Access Compliance Report

Public Rights-of-Way

(Curb Ramps)

Intersection ID: 20567	Main Street: PARK_SOUTH_DR	Cross Street: PINE_VALLEY_RD	Location: NW
ADA ID: FA7B68305FFD	Ramp Type: PerpDiag	Initial Pass/Fail: Fail	Overall Compliance: No
			Severity Score: 21.25

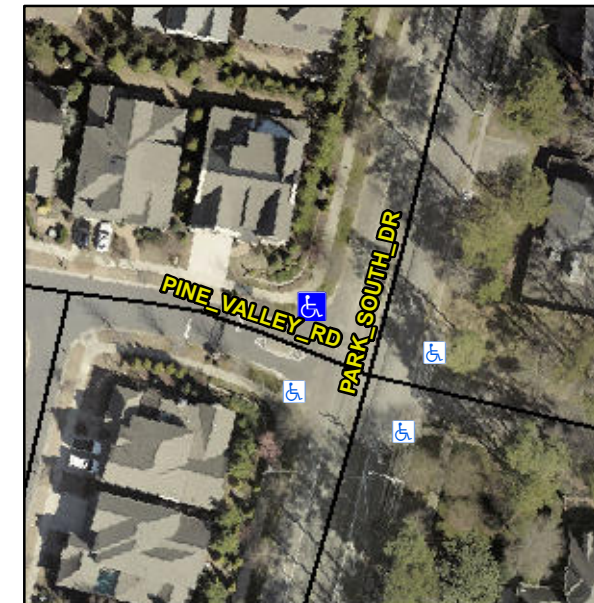
Not Found, R304.5.1, R304.5.3

Compliance	Description	Data	Compliance	Description	Data
N/A	Ramp Length (in)	100.0	Yes	Ramp Slope (%)	6.4
No	Ramp Width (in)	47.5	No	Ramp XSlope (%)	6.5
N/A	Flare Type LT	N/A	N/A	Flare Type RT	N/A
N/A	Flare Slope LT (%)	N/A	N/A	Flare Slope RT (%)	N/A
N/A	Flare Traversable LT?	N/A	N/A	Flare Traversable RT?	N/A
N/A	Landing Length (in)	N/A	N/A	DWS Provided?	N/A
N/A	Landing Width (in)	N/A	N/A	DWS Contrast?	N/A
N/A	Landing Slope (%)	N/A	N/A	DWS Length (in)	N/A
N/A	Landing X Slope (%)	N/A	N/A	DWS Full Width?	N/A
N/A	Landing Curb? (Y/N)	N/A	N/A	DWS Offset (in)	N/A
N/A	Shared Landing?	N/A			
N/A	Gutter Ponding?	N/A	N/A	Gutter Slope (%)	N/A
N/A	Gutter Lip Ht (in)	N/A	N/A	Gutter X Slope (%)	N/A
N/A	Painted X Walk1?	No	N/A	Painted X Walk2?	No
	X Walk 1 Direction	To SW		X Walk 2 Direction	To SE
N/A	X Walk 1 Width (in)	N/A	N/A	X Walk 2 Width (in)	N/A
	X Walk 1 Slope (%)	2.4		X Walk 2 Slope (%)	4.0
	X Walk 1 X Slope (%)	3.9		X Walk 2 X Slope (%)	3.3

Remove & Replace Curb Ramp With Two New Directional Ramps or Equivalent.
